Rezoning Transportation Analysis

Petition Number: 2018-128

Date	Description
11-19-2018	First Review
12-20-2018	Second Review (MH)

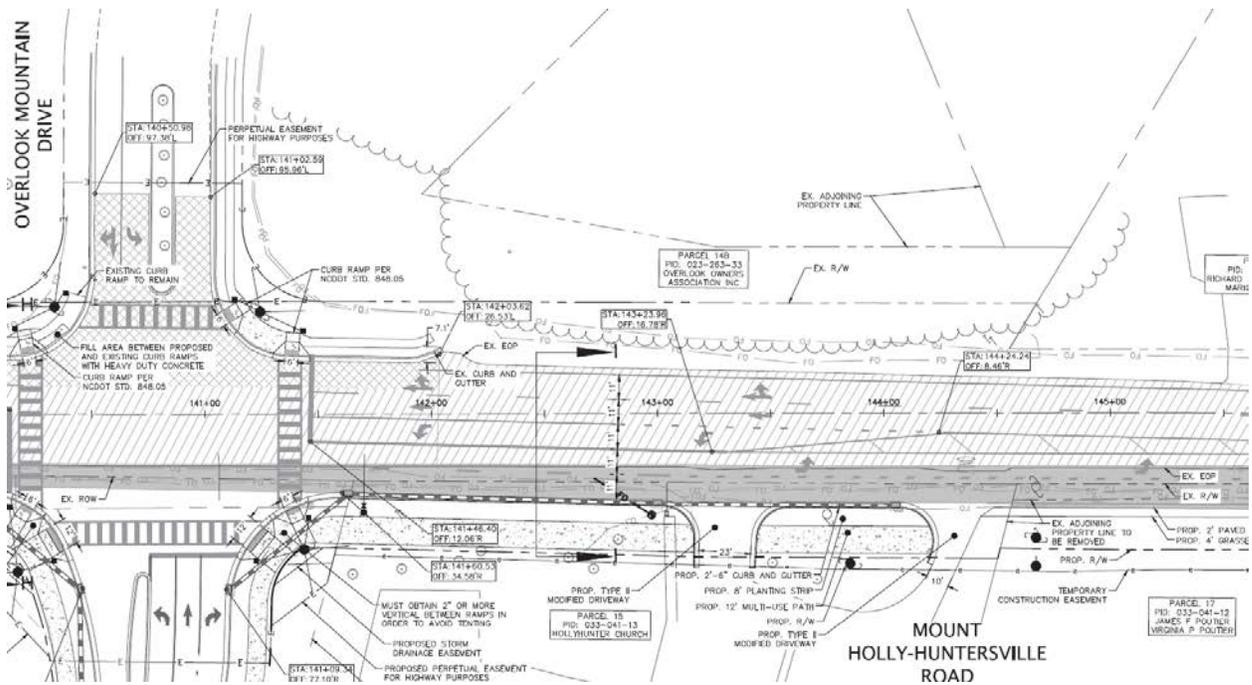
Curbline The proposed zoning district has a setback measured from back of the existing or proposed future curbline. The location of the future back of curb needs to match the recent approved Mt Holly-Huntersville Rd. Widening Plans to a 4-lane divided facility (see below approved Riverbend Roadway construction plans) to establish the future back of curb location. **Additional information:** The site plan should commit to the dedication of right-of-way for the ultimate cross-section for Mount-Holly-Huntersville Road based.

- a. Existing MHH and propose right-of-way lines
 - b. Proposed MHH future back of curbline (as determine from approved Riverbend Roadway plans to accommodate a 4-lane divided facility).

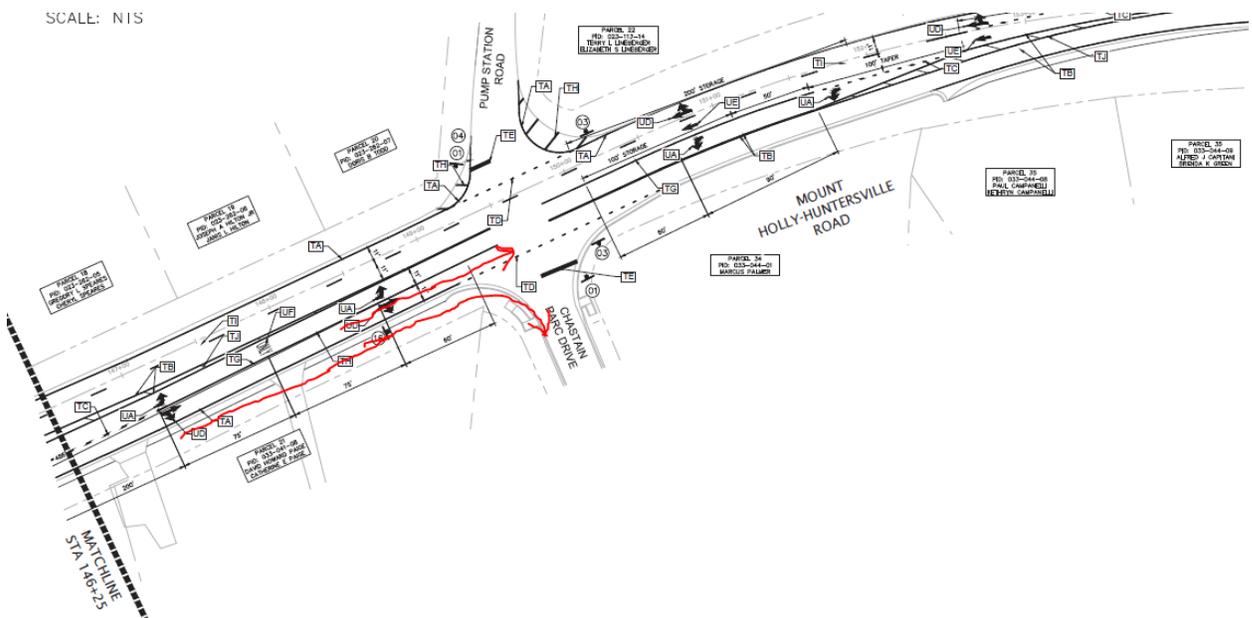
4. The petitioner should revise the site plan and conditional note(s) to depict, label and commit to an additional 11' eastbound MHH travel lane which will terminate as a right-turn drop lane at Chasten Parc Dr. (see approved MHH roadway plans below).
